Model: Model J-C2	Date: 21-Jun-05	No.: MB178001a
-------------------	-----------------	----------------

MB Correction

Modified Article: Development Unit		Prepared by: S.Yoshiki	
From: 1st Tech. Support Sec. Service Support Dept.			
Reason for Modification:	☐ Parts catalog correction	☐ Vendor change	☒ Other
	☐ To facilitate assembly	☐ To improve reliability	☐ To meet standards
	☐ Part standardization	☐ Product Safety	()

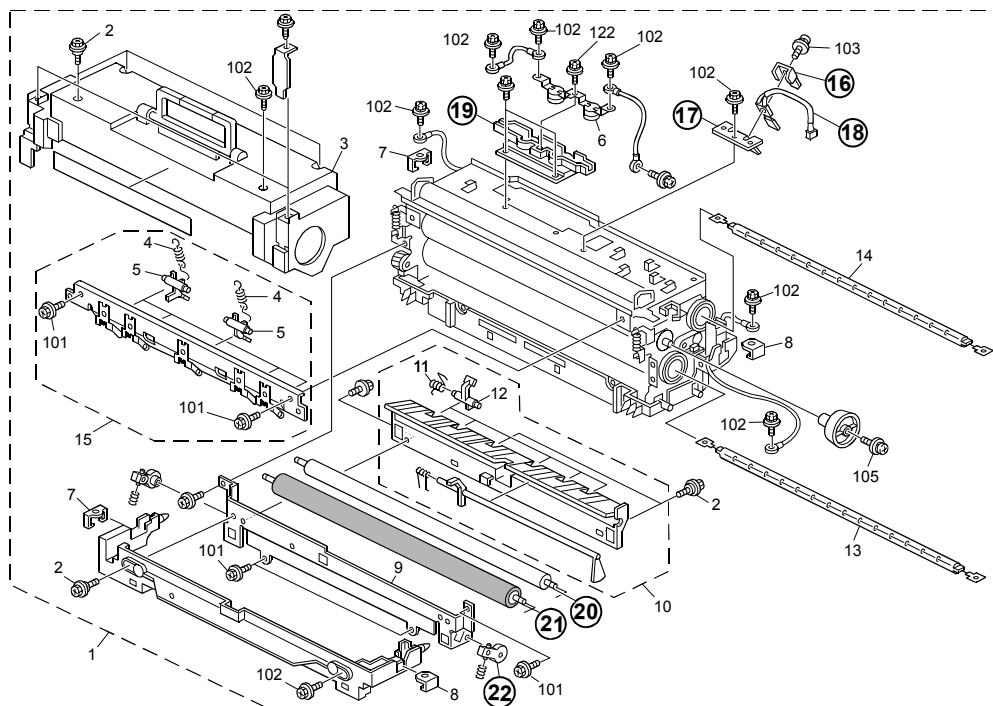
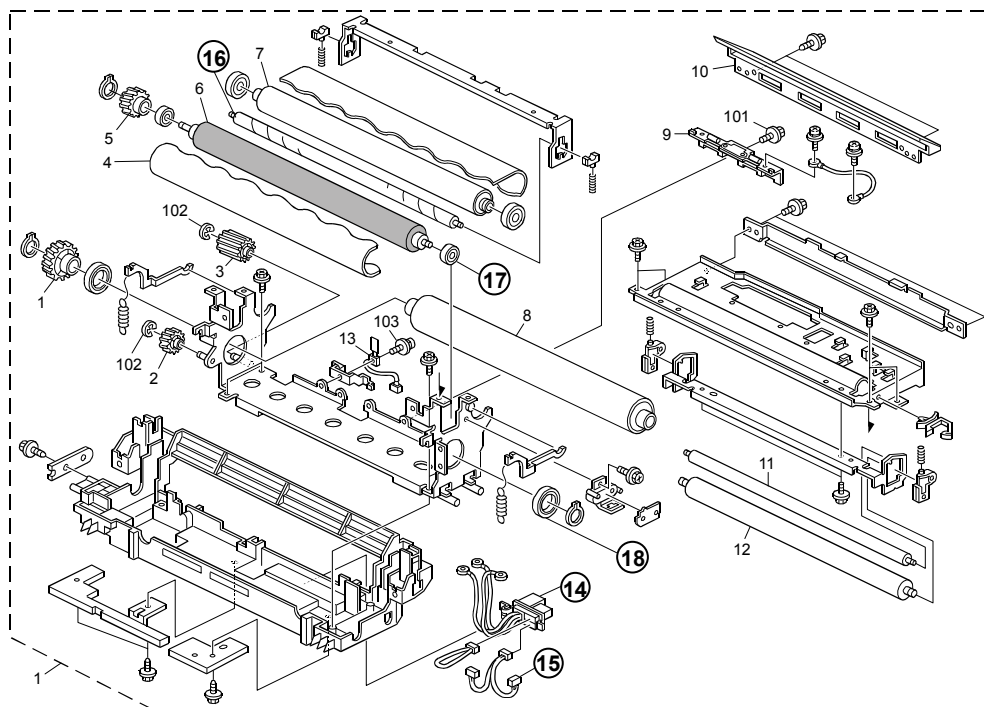
These parts were added to the illustration and the parts list.

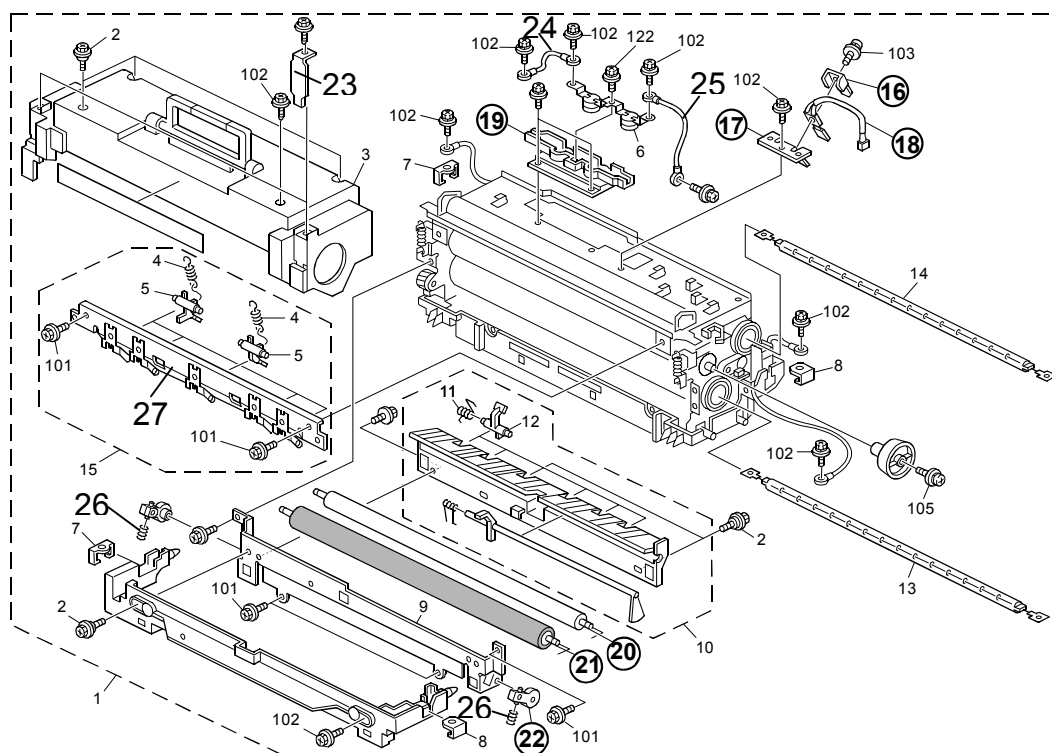
Change: The shape of the pick-off pawl was changed.

Reason: To make sure the pick-off pawl does not damage the fusing belt when jammed paper is removed.

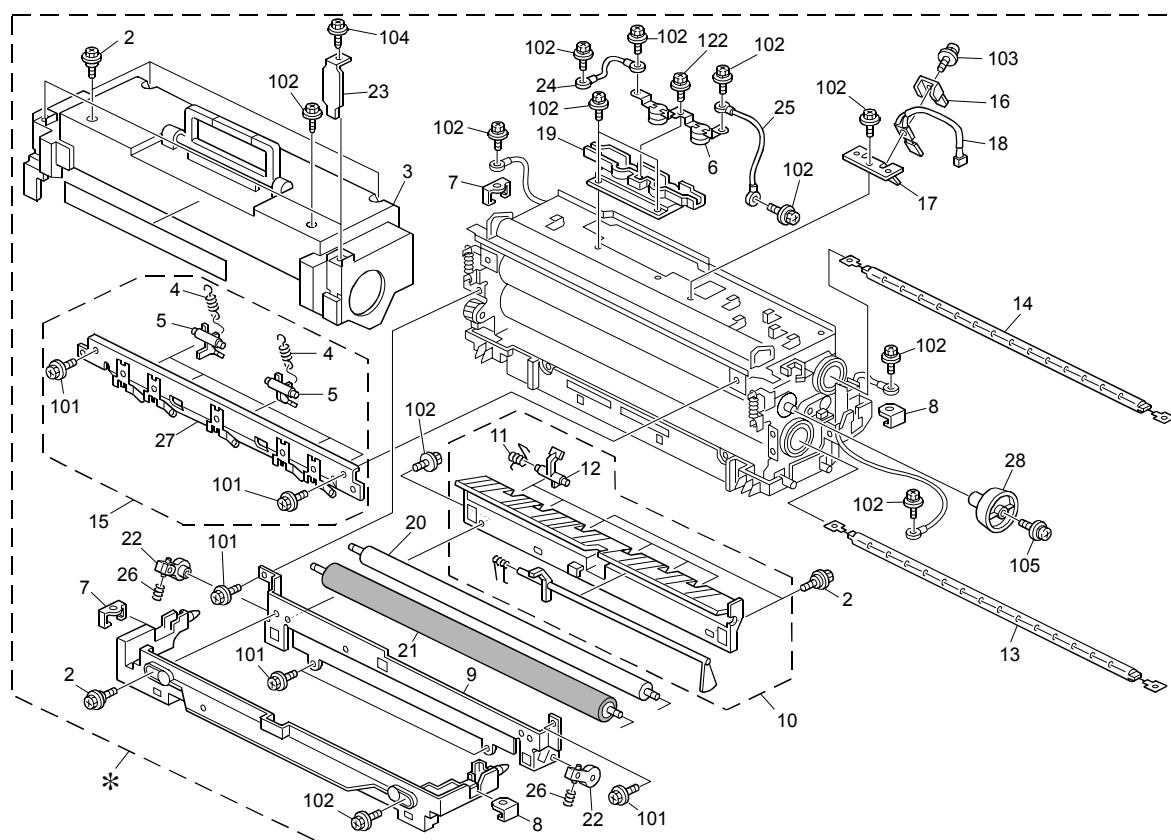
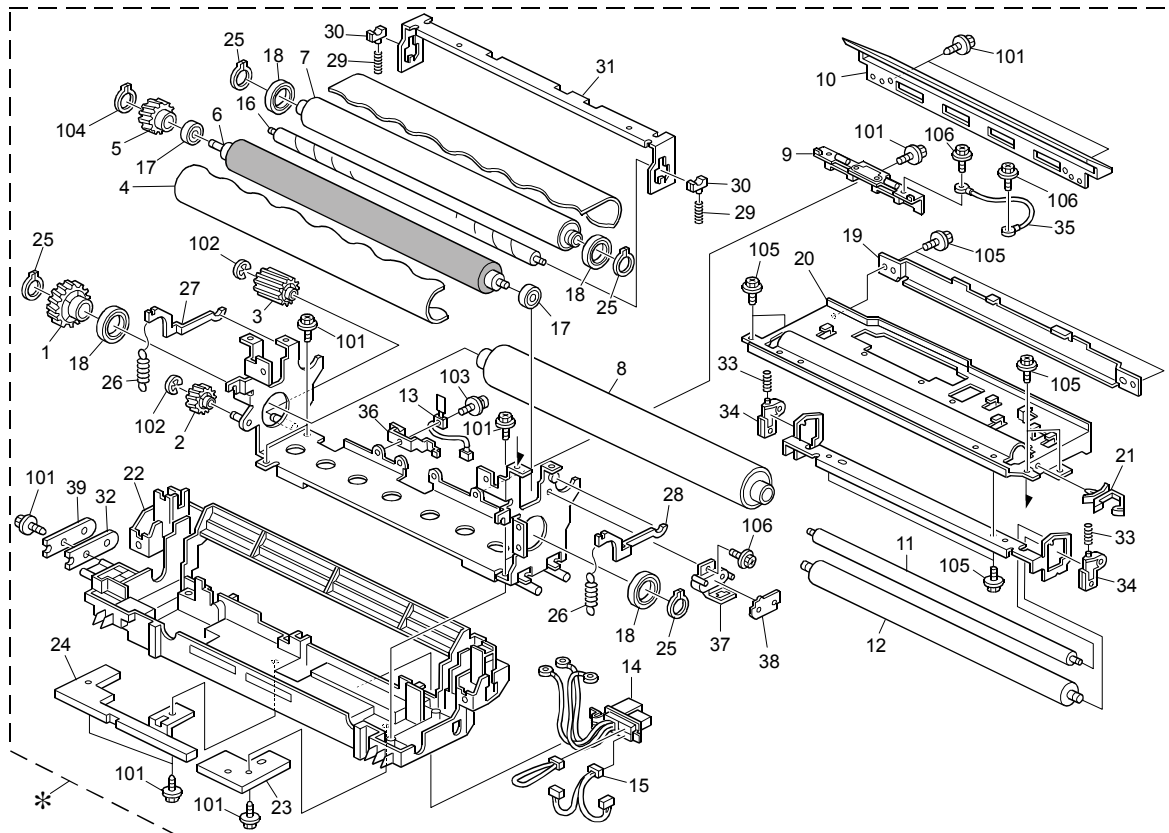
Note *1: See MB178005
Note *2: These two parts were listed on pg. 63 by mistake.
Change/Reason:

These parts were added to the illustration and the parts list.

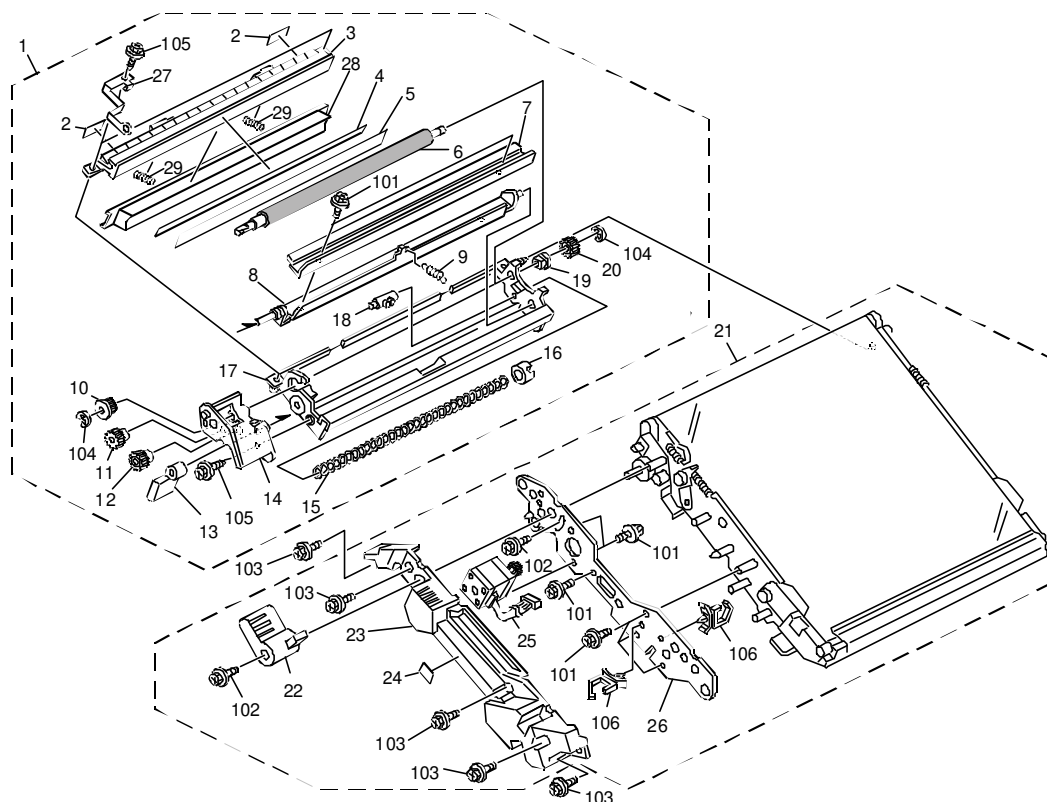
Change: The parts in the table were changed or added.

Reason: To further improve transfer belt cleaning performance.

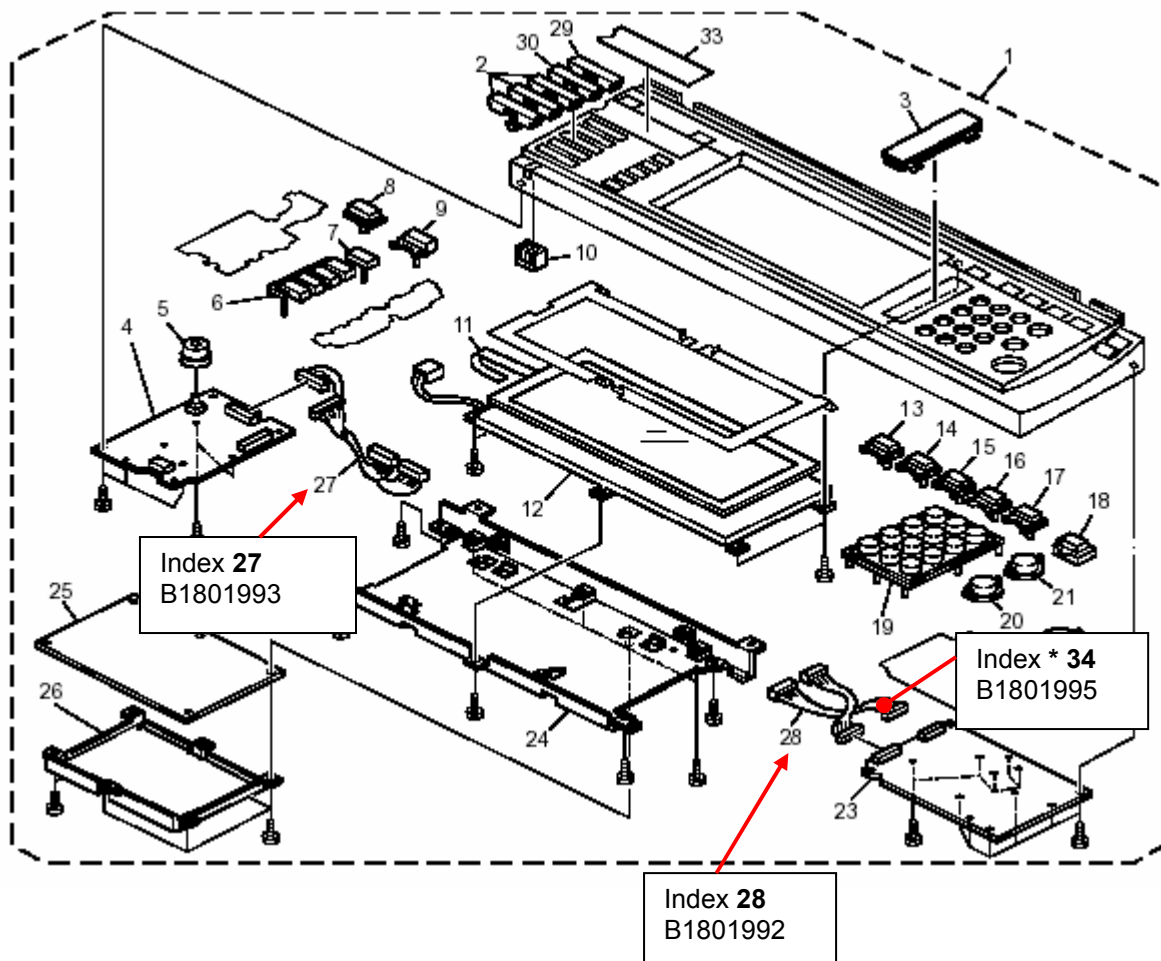
Change: The P/Ns in the table were added, and the illustration was corrected.

Reason: The P/Ns were not listed in the Parts Catalog.

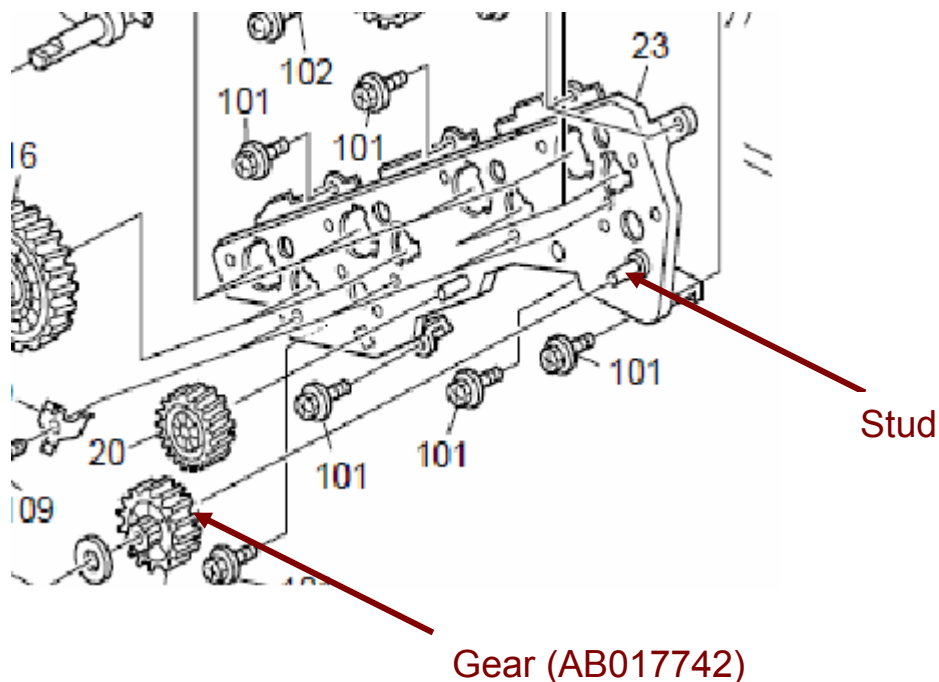
Change: The shapes of the bracket and gear in the drum drive unit were changed.

Reason: To further ensure that the gears engage (with the old gear, the stud sometimes bends and the gears do not engage).
